BLT Conditional Use Appeal Response (1a)

This letter is Build Lebanon Trails (BLT)'s response to the written testimony from NIMBY that was submitted to the planning commission during the 12.10.24 commission hearing on Planning File No. PD24-0237; a Conditional Use Permit for a public trail.

This letter is to serve as additional written testimony for the Linn County Planning Commission hearing on Planning File No. PD24-0237; a Condition Use Permit for a public trail on properties identified by the Linn County Tax Assessor Map No. T12S, R02W, Section 11AC, Tax Lot 1200 and T12S, R02W, Section 11BD Tax Lot 2000.

Figure 1 Subject Properties and Adjacent Properties

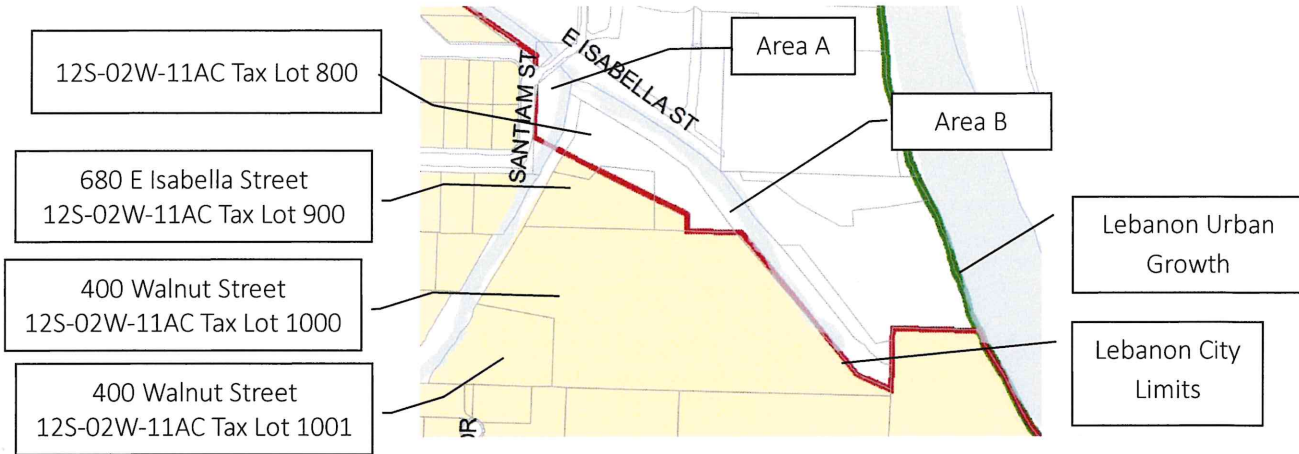
1. The County and Applicant has failed to address LDCD 933.260(B)(4) about how the location, design, and site planning of the proposed development will not preclude future urban development on adjacent properties.

It is contested that the County and Applicant fail to include adequate provisions to ensure that adjacent properties (landlocked by the subject property) are provided street and utility access to/from the East Isabella Street and Santiam Street rights-of-way via either a private access/utility easement or right-of-way dedication.

The subject properties are identified by Linn County Assessor's Map No. 12S-02W-11-BD Tax Lot 2000 ("Area A") and 12S-02W-11AC Tax Lot 1200 ("Area B"). The subject properties are depicted on Sheet 2 of Linn County Boundary Survey No. 27504 as VOL. 469, PG. 790 and VOL. 469, PG 790.

Adjacent properties are identified by Linn County Assessor's Map No. 12S-02W-11AC Tax Lots 800, 900, 1000, and 1001. Tax Lots 800 and 900 are also illustrated on Sheet 2 of Linn County Boundary Survey No. 27504 as DN 2023-06064 and DN 2019-22207.

The adjacent properties are entirely within the Lebanon Urban Growth Boundary with portions within and/or contiguous to the Lebanon city limits. Tax Lot 900 (680 E. Isabella Street) is designated as Residential Low Density on the Lebanon Zone Map. Tax Lot 800 is designated at UGA-UGM-10 on the Linn County Zone Map. Both properties are designated as Mixed Use on the Lebanon Comprehensive Plan. Both properties are also identified in Lebanon Buildable Lands Inventory as “buildable land” that are “suitable, available, and necessary” for residential uses.

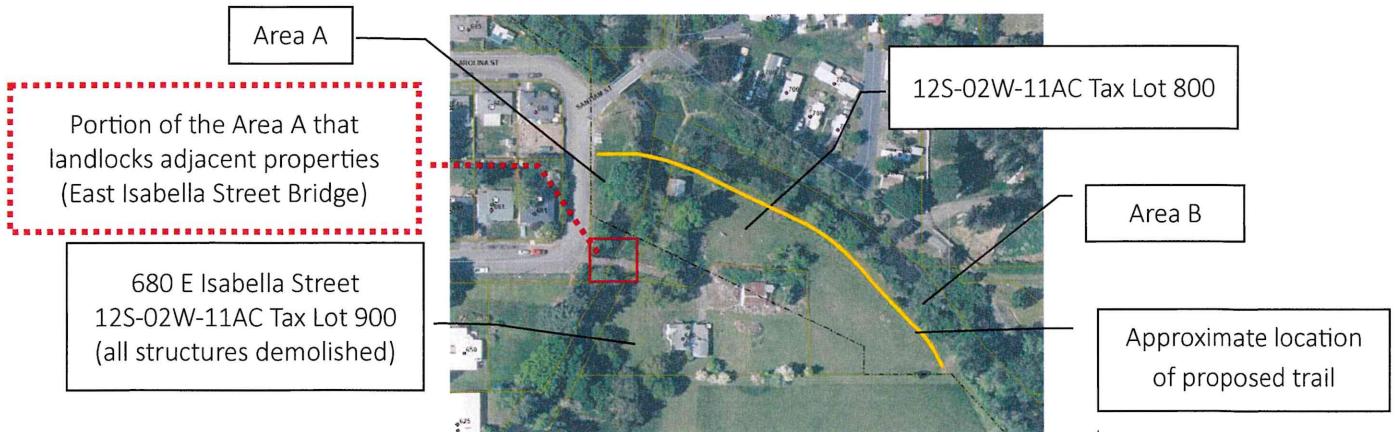
Currently, there is a single-lane vehicular bridge (East Isabella Bridge) spanning across the subject property (12S-02W-11-BD Tax Lot 2000, Area A) from east side of the Santiam Street right-of-way to the adjacent properties. Although a bridge exists, the Applicant has failed to produce evidence of a recorded access and utility easement with a maintenance agreement nor has a right-of-way dedication been proposed in association with the public trail development proposal.

The absence of a recorded access and utility easement with a maintenance agreement or a right-of-way dedication over the subject property (“Area A”) precludes future development of adjacent properties as this is the only access point that has adequate area for development of a full street system in compliance with the city’s design and improvement standards.
